ZTE CORPORATION**Product Change Description**

[Z791G]
[ZTE Corporation]

is the variant of the initial certified product,

[Z791]
[ZTE Corporation]

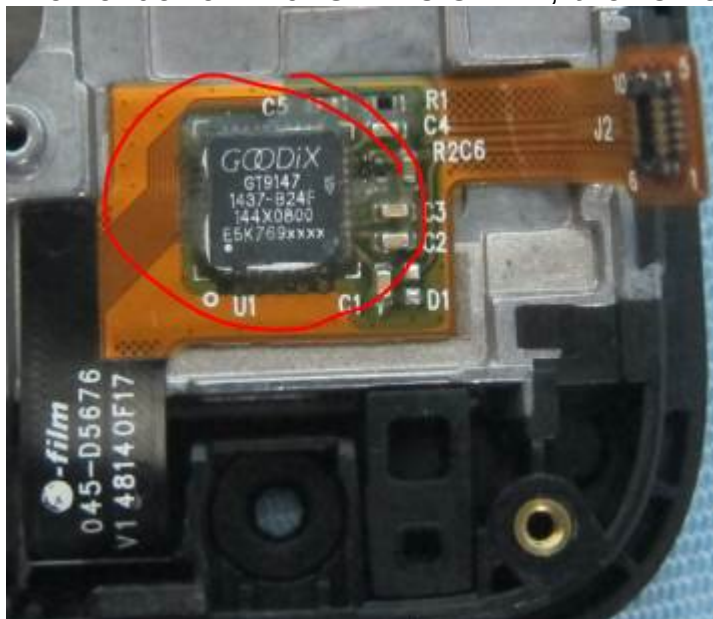
Other changes: Yes

The SIM card socket is changed from push-push type to push-pull type

The earphone jack is changed from 13.1X6.6X4.55mm to 8.7*12.66*4.2mm
